January 13, 2025

RE: 94 4th St. CPD;
DCI2024-00024

Please accept the following information in response to your November 13, 2024 correspondence regarding the referenced project.

**PRELIMINARY
SITE PLAN
DRIVEWAY OPTION 3**

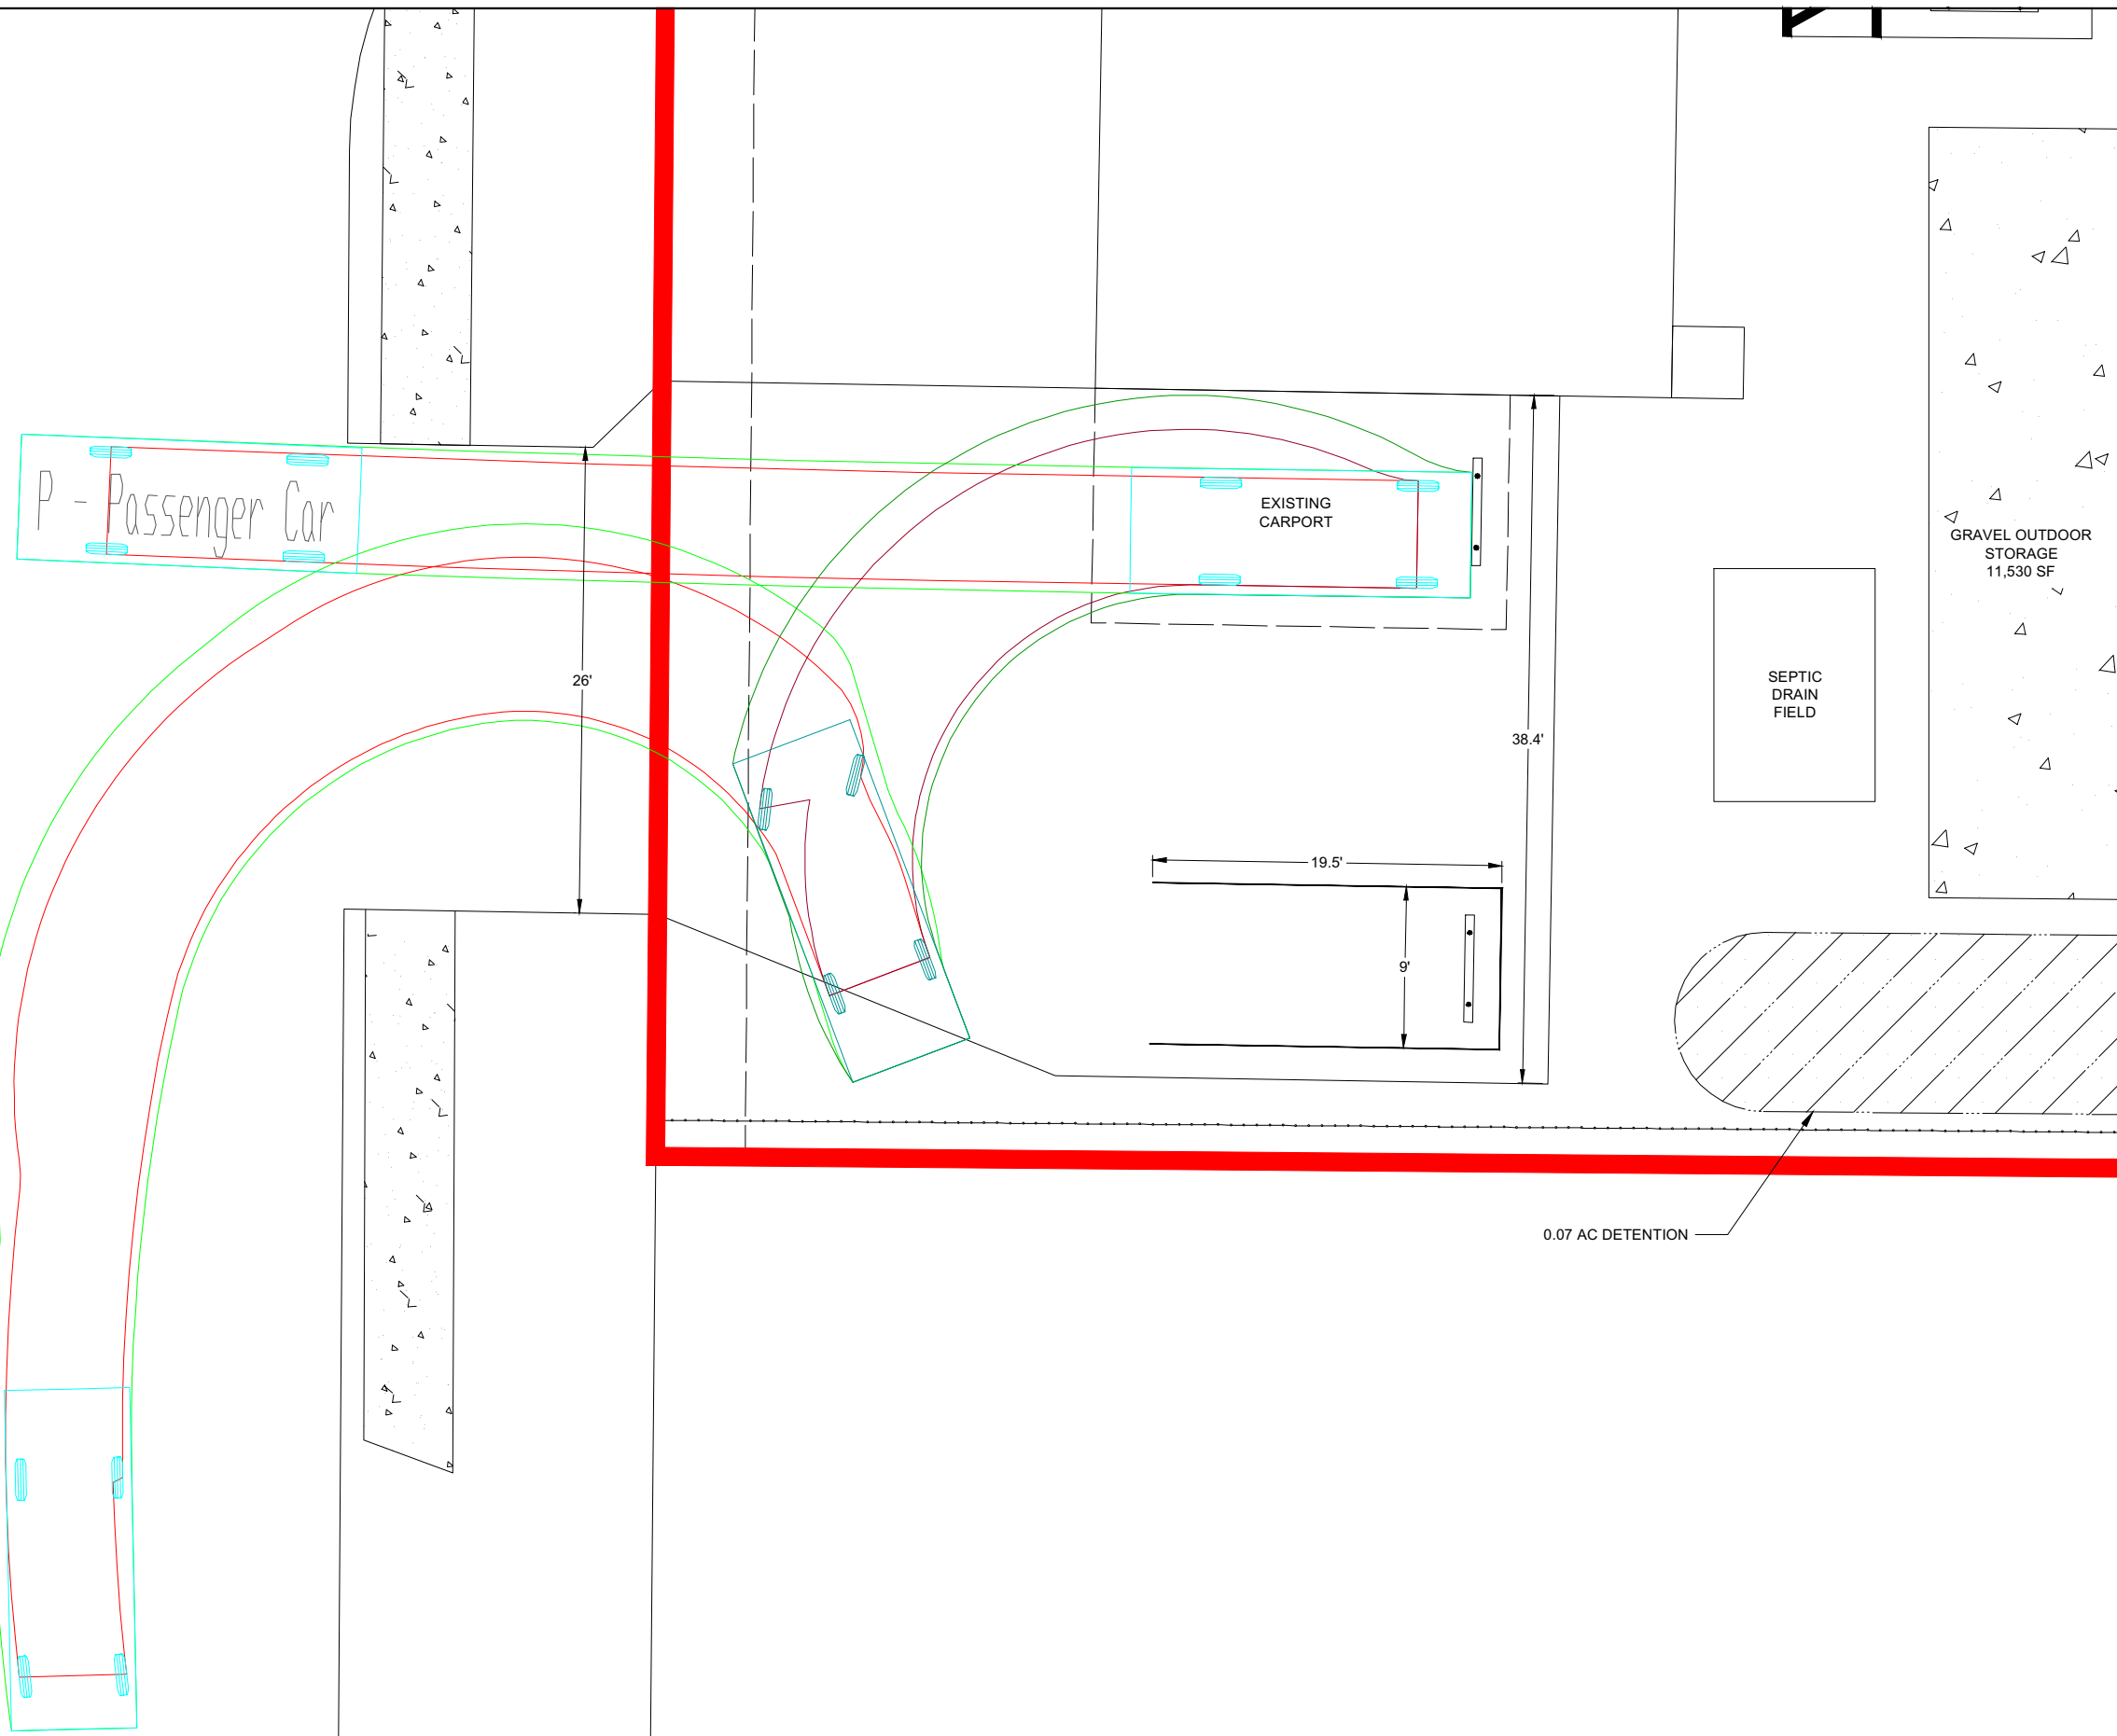
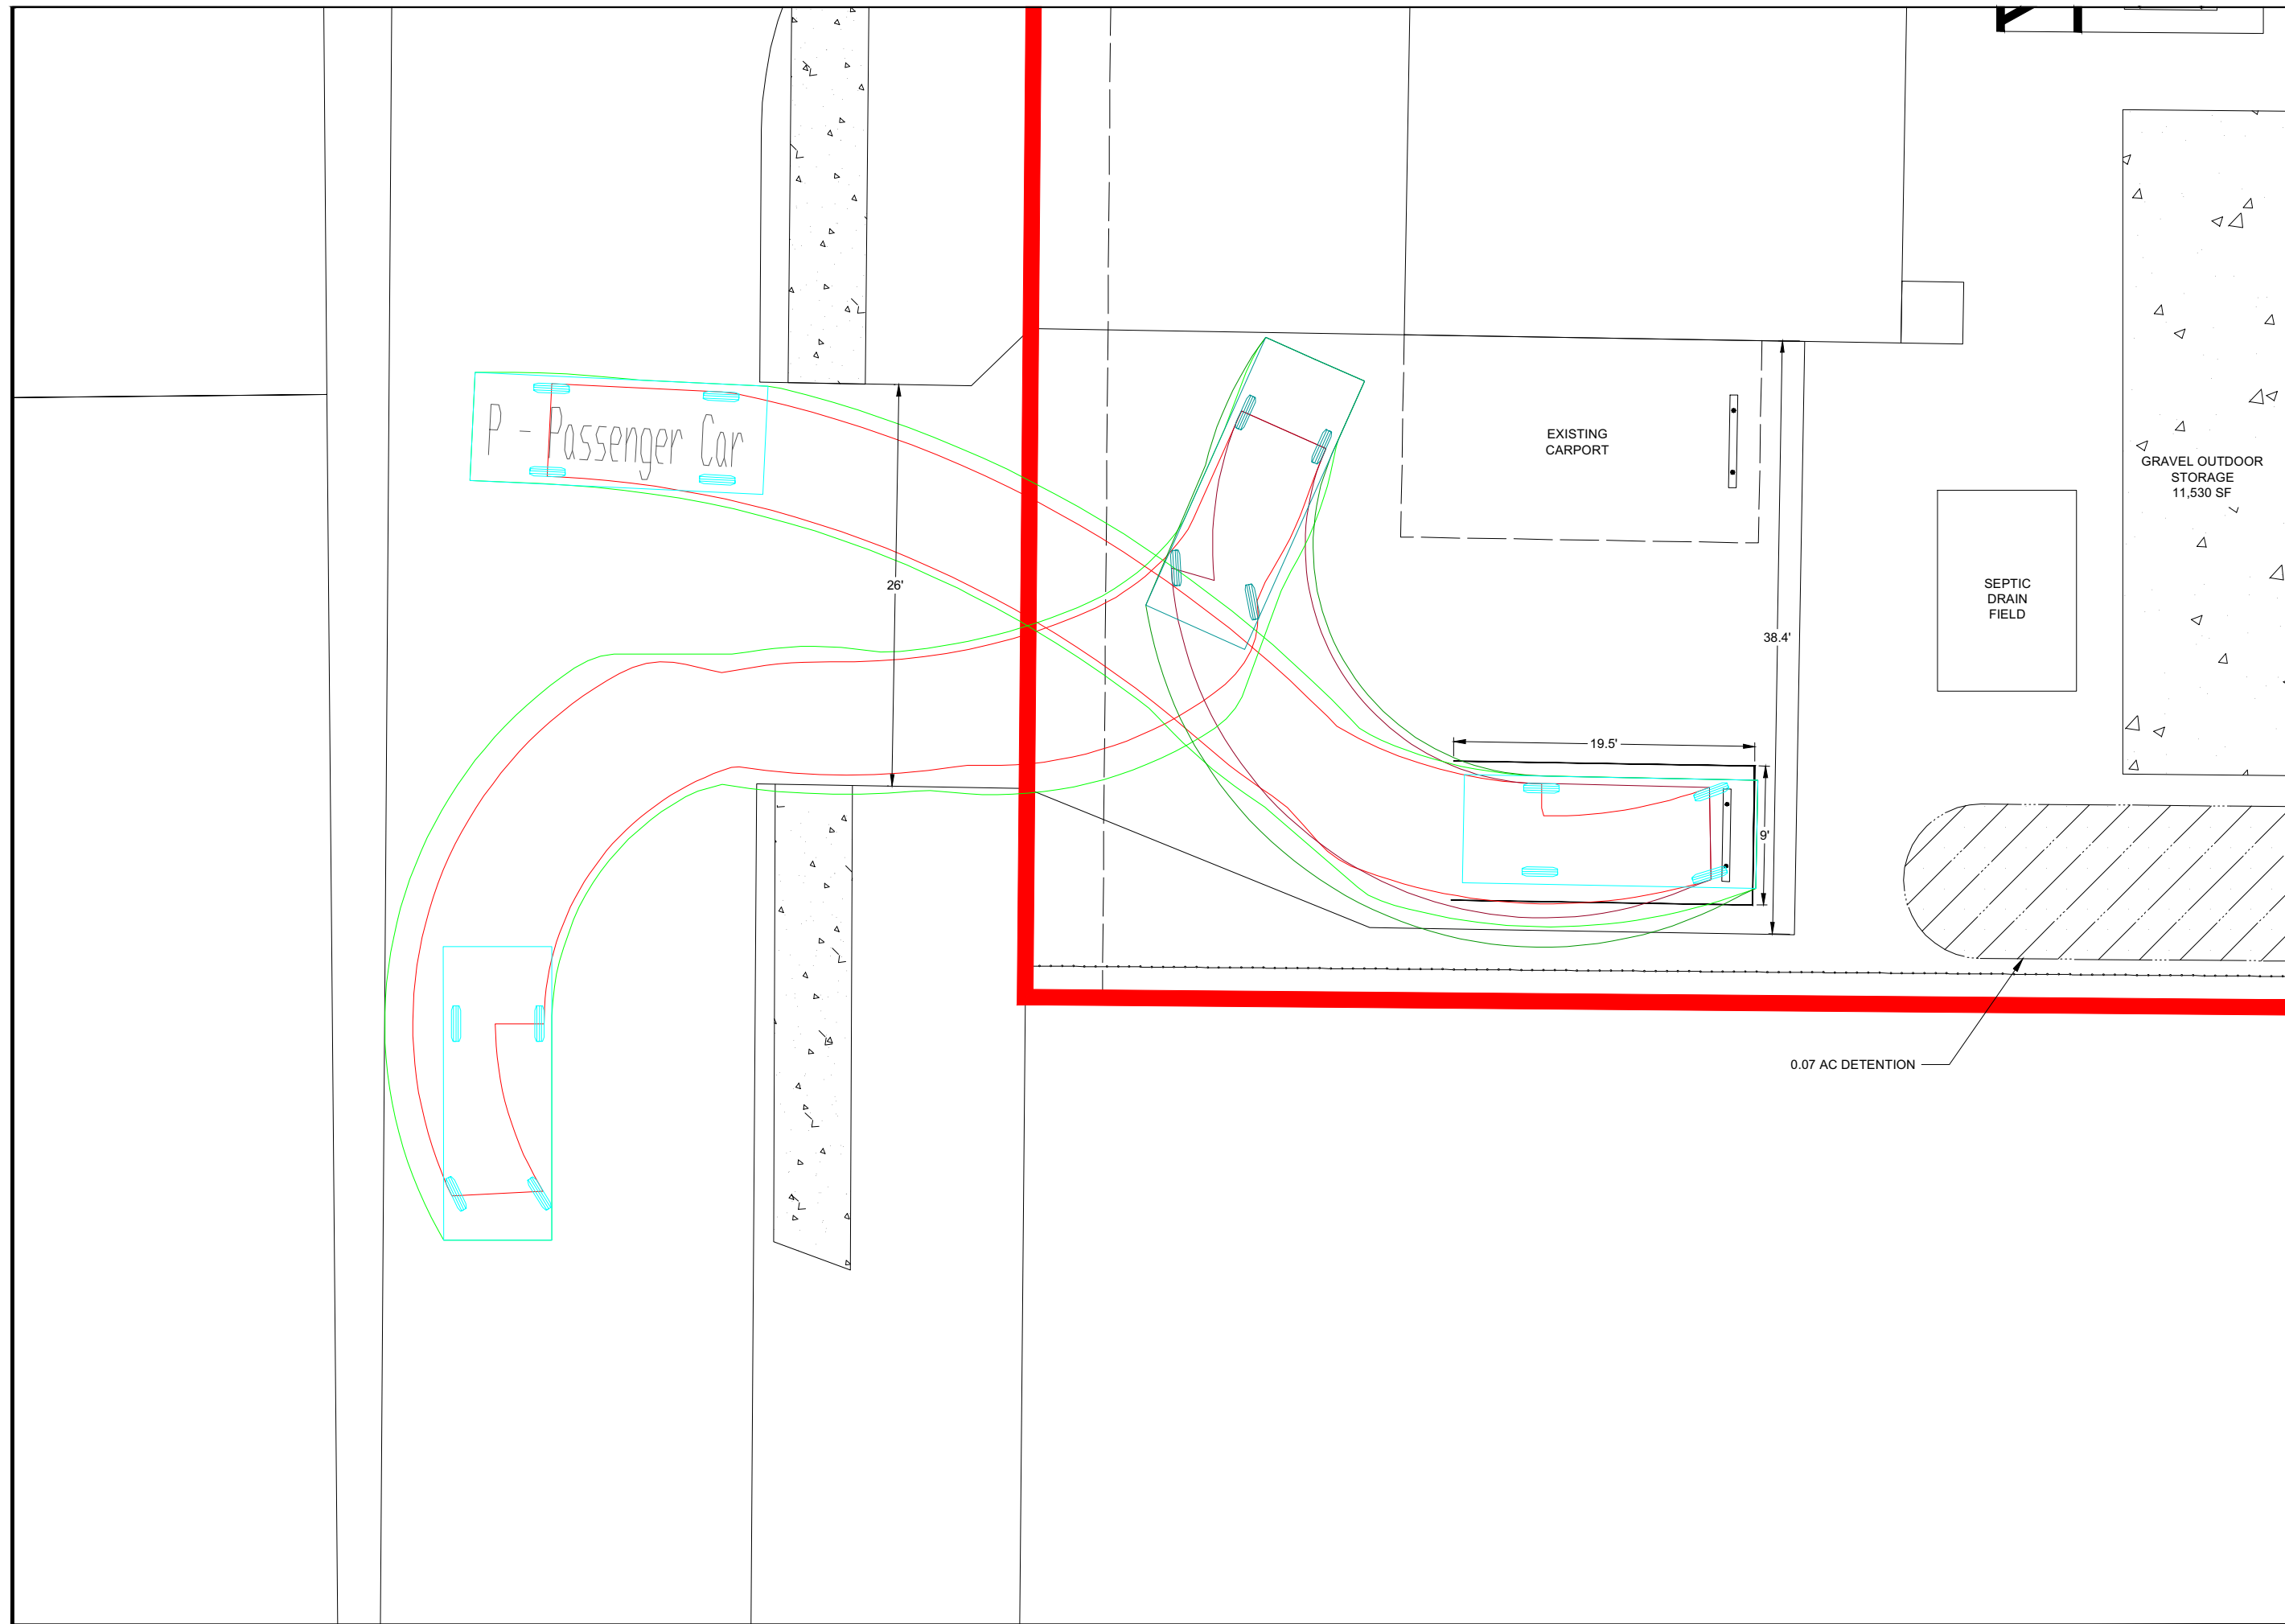
There is an “existing carport” called out; per LDC Section 34-2015(2) (d) you will need to demonstrate sufficient maneuvering room to allow an exiting vehicle to leave the parking lot in a forward motion. If unable to demonstrate compliance a deviation may be requested to allow an alternative.

The driveway stub out has been added to allow an automobile in the carport to reverse into the stub out and pull forward onto 4th St. Turning radius diagrams have been included.
